Access Compliance Report Public Rights-of-Way (Curb Ramps)

Main Street: ARROYO_AVE Cross Street: CASTLEGATE_LN Location: S

ADA ID: RPRK211011110018 Ramp Type: Type 1 - Perpendicular Initial Pass/Fail: Fail Overall Compliance: No Severity Score: 30

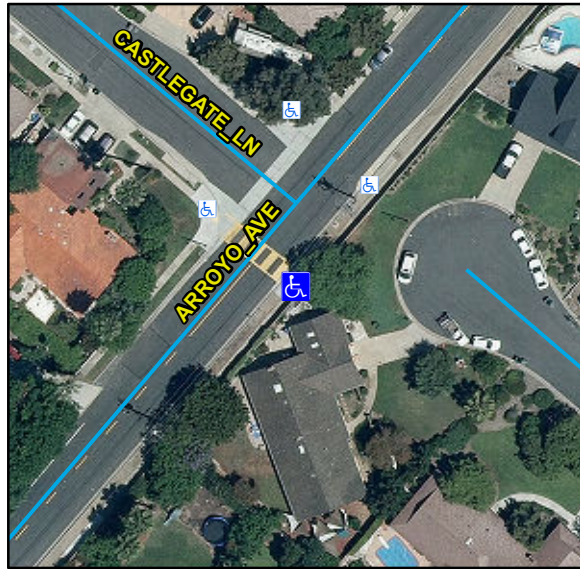
Compliance	Description	Data	Compliance	Description	Data
N/A	Ramp Length (in)	110	N/A	Flare Type LT	
Yes	Ramp Width (in)	48			N/A
No	Ramp Run Slope (%)	13.1	N/A	Flare Slope LT (%)	N/A
Yes	Ramp Cross Slope (%)	0.7	N/A	Flare Traversable LT	N/A
N/A	Landing Present	N/A	N/A	Flare Type RT	
N/A	Landing Length (in)	N/A			N/A
N/A	Landing Width (in)	N/A	N/A	Flare Slope RT (%)	N/A
N/A	Landing Run Slope (%)	N/A	N/A	Flare Traversable RT	N/A
N/A	Landing Cross Slope (%)	N/A	N/A	DWS Provided	N/A
N/A	Landing Movement Obstructed?	N/A	N/A	DWS Contrast	N/A
	Landing Movement Type	N/A	N/A	DWS Length (in)	N/A
N/A	Landing Shared	N/A	N/A	DWS Full Width	N/A
N/A	Clear Space	N/A	N/A	DWS Offset Left (in)	N/A
N/A	Clear Space To Crosswalk (in)	N/A	N/A	DWS Offset Right (in)	N/A
N/A	Marked Crosswalk 1	Yes	N/A	Marked Crosswalk 2	N/A
	Crossing 1 Direction	NW		Crossing 2 Direction	N/A
	Marked Crosswalk 1 Width (in)	144		Marked Crosswalk 2 Width (in)	N/A

N/A	Ramp Inside Crosswalk 1	Yes	Yes	Ramp Inside Crosswalk 2	N/A
	Crossing 1 Slope (%)	6.6		Crossing 2 Slope (%)	N/A
	Crossing 1 Cross Slope (%)	2.2		Crossing 2 Cross Slope (%)	N/A
N/A	Gutter Ponding	N/A	No	Curb Slope	15.4
Yes	Gutter Lip Height (in)	0		Road Run Slope (%)	2.2
N/A	Gutter Run Slope (%)	N/A		Road Cross Slope (%)	3.5
N/A	Gutter Cross Slope (%)	N/A			
Yes	Overall Surface Condition: Acceptable		Yes	Perp Joint Present	Yes
	Cross Gutter Present?	No		Spandrel Present?	No
	Replace Cross Gutter?	No		Replace Spandrel?	No

Possible Solutions:

Remove & Replace Entire Ramp.

R304.2.2, STD 1115
